CITY OF HOOD RIVER

MEMORANDUM

To: City of Hood River Planning Commission
From: Jennifer Kaden, Associate Planner
Date: July 9, 2020
RE: Appeal of File No. 2020-07; Irving THmP

To: Bill Irving, Owner & Applicant
From: Jennifer Kaden, Associate Planner
Re: File No. 2020-07 – Minor Partition for a Townhouse Project

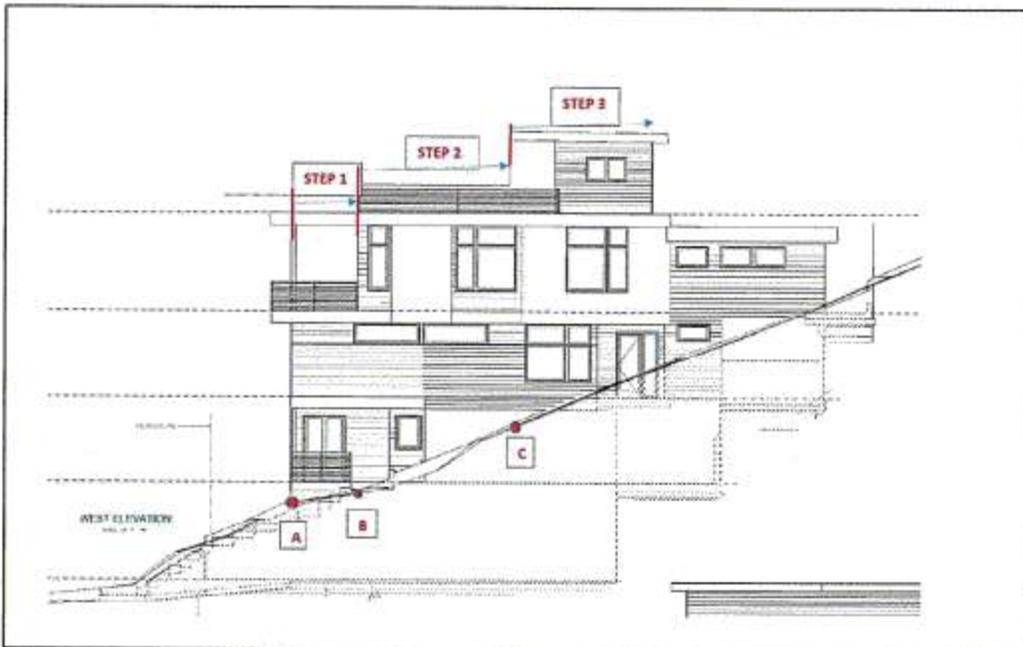
The code permits roof eaves to encroach into the eastern and western side setbacks as described above. The roof plan (Sheet 4, Attachment A.2) depicts 1'3" roof eaves that will

encroach into the side setbacks in conformance with the standard. **A condition of approval is included to require that the building permit plans for the proposed townhouse project verify the roof eaves encroach no more than 15 inches into the side setbacks.**

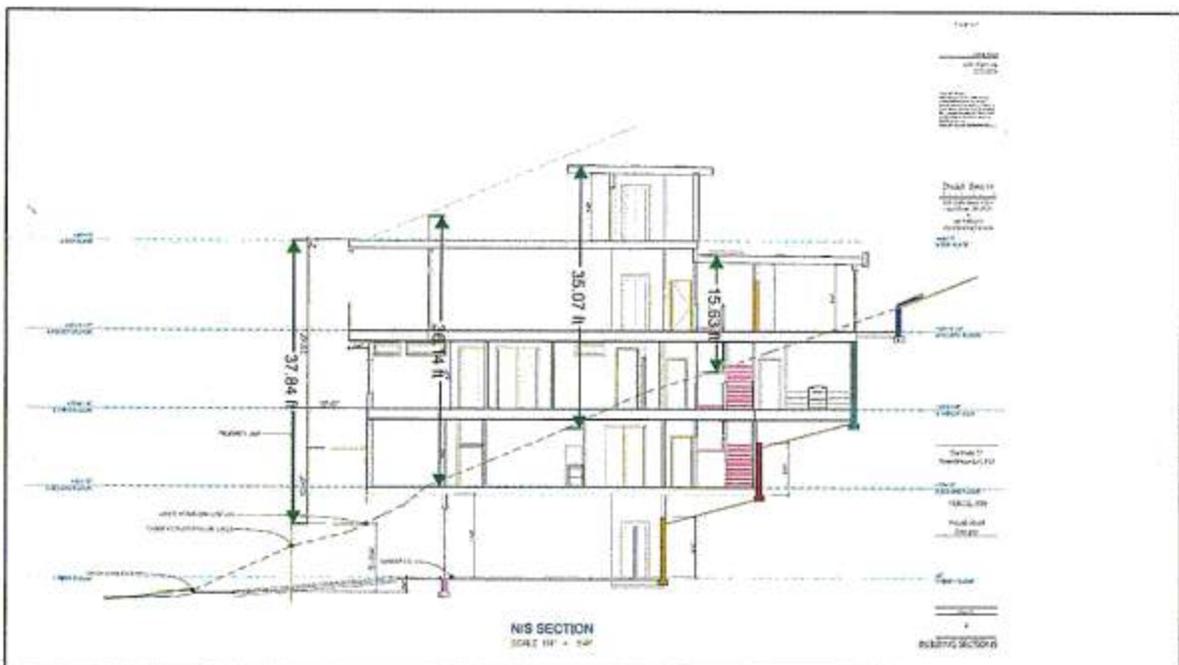
The project narrative and plans indicate that the property owner intends to construct townhomes that do not exceed 28 feet in height in order to use the 5-foot side setback standard. Topographic information from the applicant indicates there is greater than 10 feet of elevation change between the upper and lower existing grades of the proposed building footprint: the existing grade elevation is approximately 229 feet at the front of the building and approximately 257 feet at the rear of the building based on the topographic information on the site plan (Sheet 1, Attachment A.2). The project plans depict a townhouse building on a steeply sloped property with a foundation built into the hillside. As viewed from the east and west, the building form steps up the hill in three segments: The first step is measured from the front (northernmost) vertical wall plane to the vertical wall plane created by a railing on the 5th level. The second step is measured from that railing to a vertical wall plane created by a partition wall on the 5th level. The third step is created from the partition wall vertical plane to the south. These steps are illustrated on the west elevation drawing:

The height is measured at a point 10 feet above the existing grade of the northern (lowest) side of each step or segment, illustrated above as basis points A, B, and C. The applicant provided a section drawing that illustrates the existing grade in relation to the building (Sheet 8, Attachment A.2), but the existing grade elevation was only provided for Step 1 (229' above sea level). Given that the building height is measured from a point 10 feet above basis points A, B & C, the maximum allowed distance from the existing grade to the highest part of the building in each segment is effectively 38 feet from existing grade. Staff used a computer program to approximately calculate the gross height of each segment (measuring from grade instead of the point 10 feet above grade):

The building height for Step 1 is measured on the downhill (northern) side of the segment as follows: the existing low grade is approximately 229 feet above sea level (ASL), thus the building height is measured from 239 feet ASL (229' + 10') and the highest point of the building for that step cannot exceed 274' ASL (239' + 35'). As illustrated on the section drawing (Sheet 8, Attachment A.2), the proposed height of the segment is approximately 2 inches below 274', in conformance with the building height standard. Additional information about the existing grade elevations and roof elevations for Steps 2 and 3 will be required to verify building height at the time of building permit review.

A condition of approval is included to require additional existing grade elevations at all building corners and as needed to verify the building heights of the stepped building. For the project as proposed, the owner is required to demonstrate the building height of any segment of the building will not exceed 28 feet as measured from a point 10 feet above existing grade of the lowest (northernmost) point of the segment. If any segment of the building exceeds 28 feet in height as measured from a starting point 10 feet above the lowest existing grade to the highest point of the proposed building for the segment, the project must be redesigned either to meet 8-foot side setbacks or to meet the 28-foot building height.

SHEET
3
FLOOR PLANS

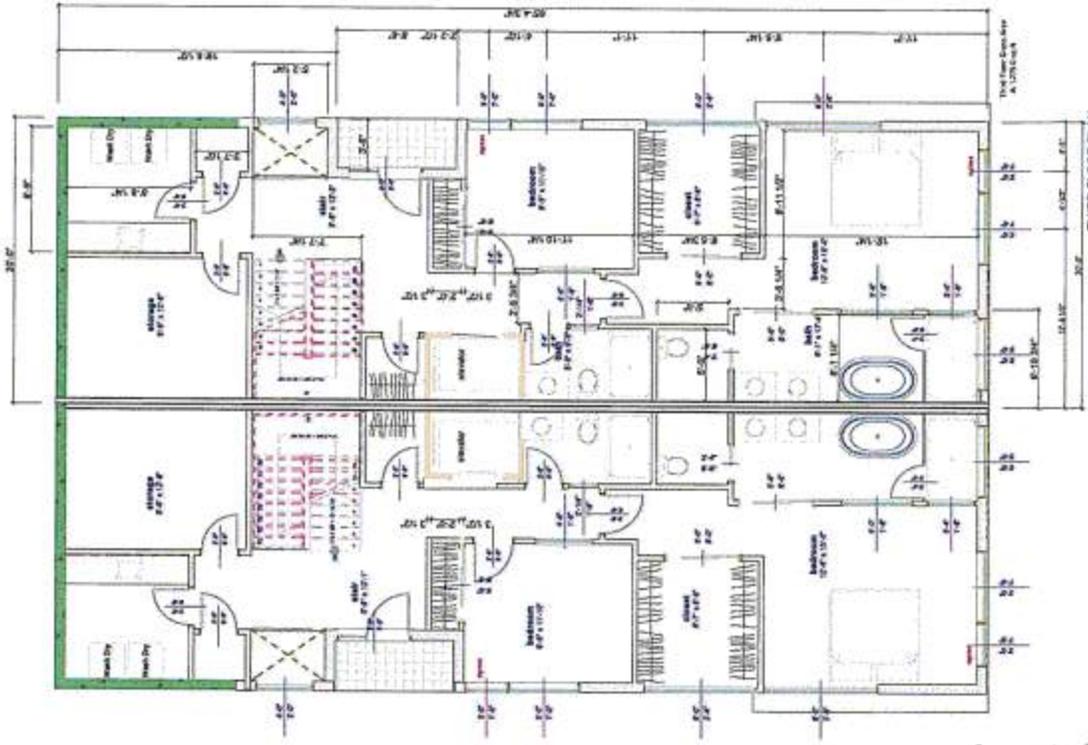
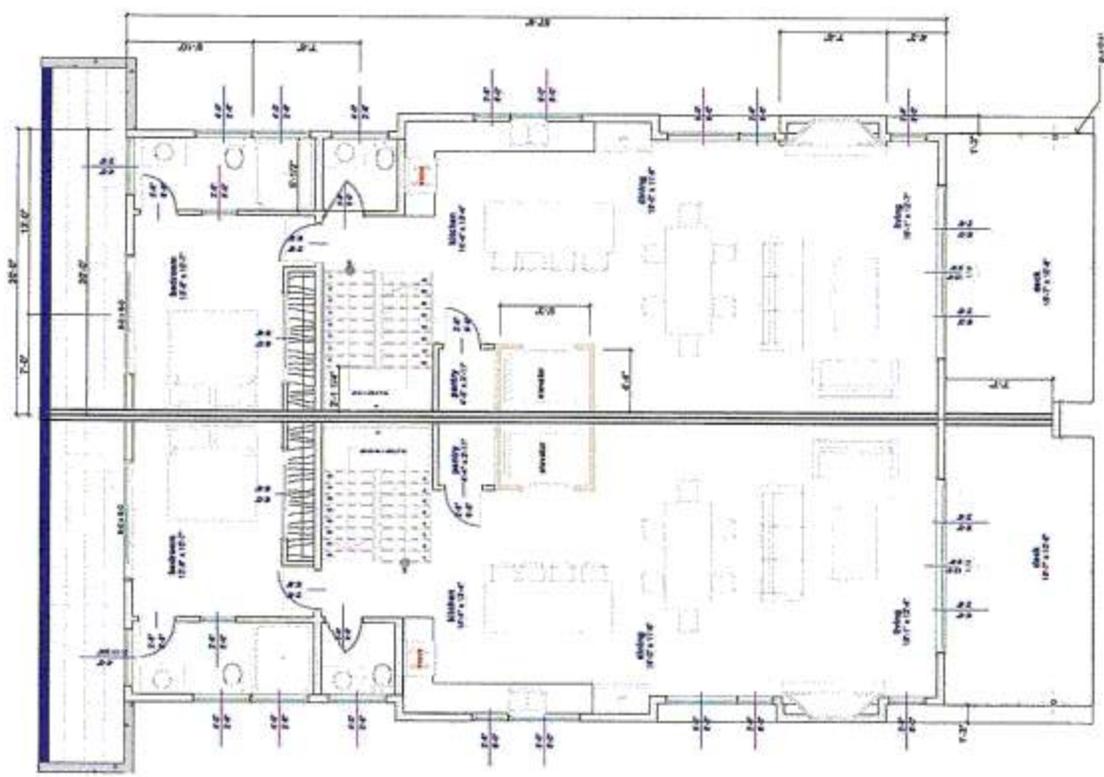
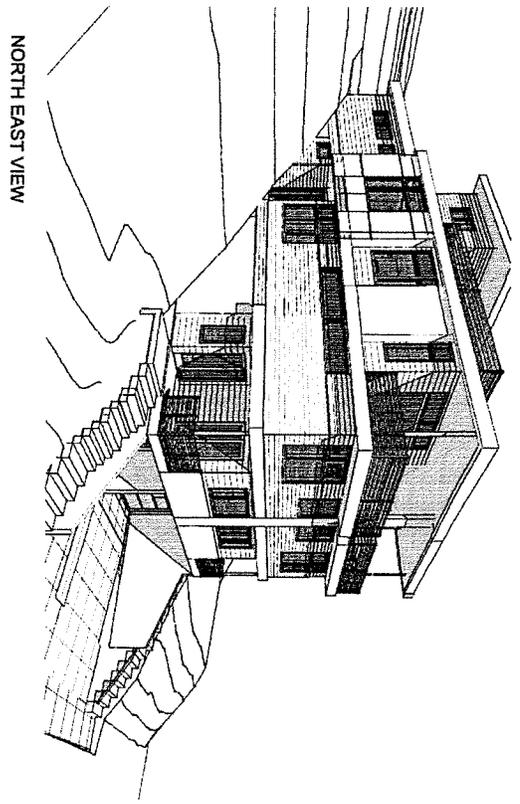
The site plan and 4th floor floorplan (Sheets 1 & 3, Attachment A.2) depict fireplaces and cantilevered kitchens (one each for each townhome) encroaching 1'3" into the side setbacks. The cantilevered kitchen differs from the types of architectural features included in the definition of "projection" because it includes usable, conditioned space. Thus, the cantilevered kitchen is not permitted to encroach into the setbacks. The fireplace, however, is similar to a chimney or flue or pilaster. As such, staff finds that the cantilevered fireplace is a projection with characteristics nearly identical to that of a chimney and, as proposed, is permitted to encroach into a side setback up to 15 inches.

As such, a condition of approval is included to require that the building plans for the proposed townhomes are modified to remove all cantilevered floor area, including the cantilevered kitchen, from setbacks and demonstrate conformance with setback standards.

15. The 4th floor decks on the north are labeled as 19'7"x10'8" making a total of 208 sq ft but the architect math on sheet 3 says 158.0 sq ft. Correct the drawings to the actual measurements.

Window projections with / without floor area

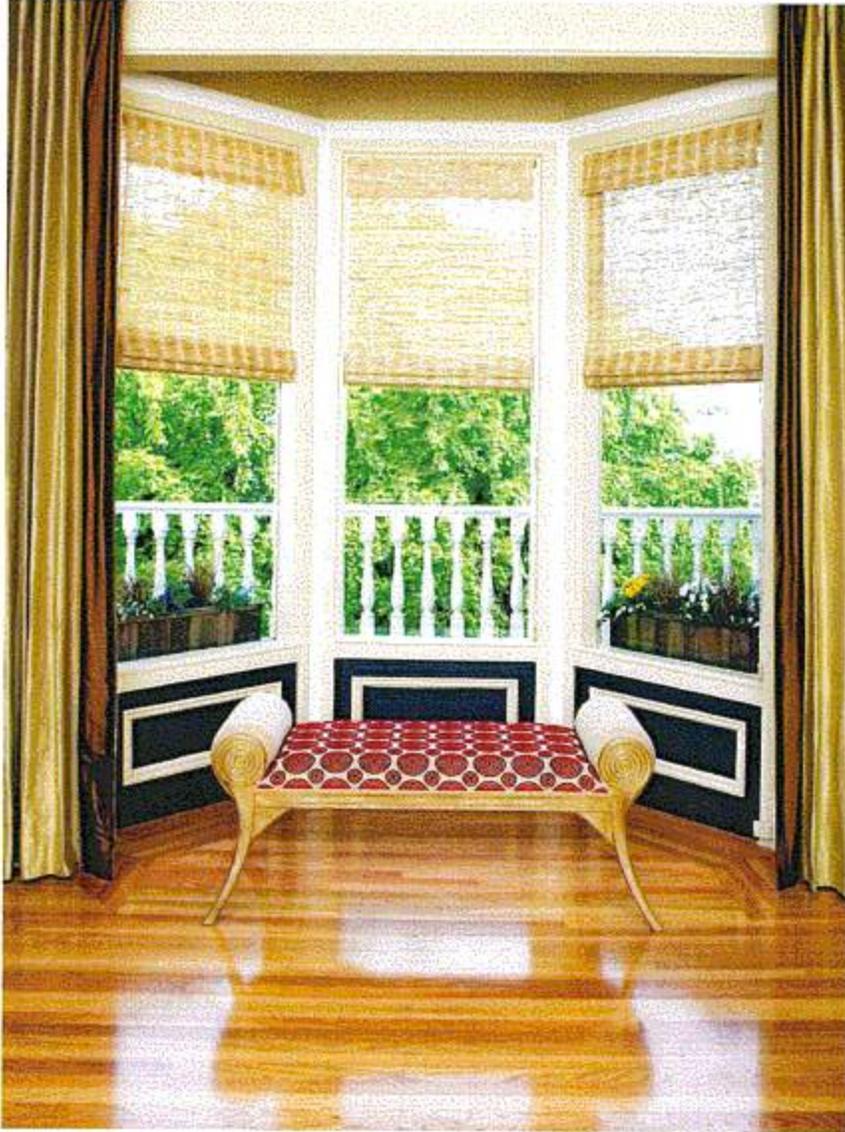
reasons. These design elements included offsets, massing, bump-out, porches, roof overhangs and cornices.

- The bump-outs as proposed integrate with the cornices, roof overhangs, and decks in an intentional and seamless manner.
- *The bump-outs as proposed fall within the maximum distance permitted by the code for projections.*
- The bump-outs as proposed contain windows, mechanical equipment, and cabinetry. *There is no useable floor area in any of the proposed bump-outs.*
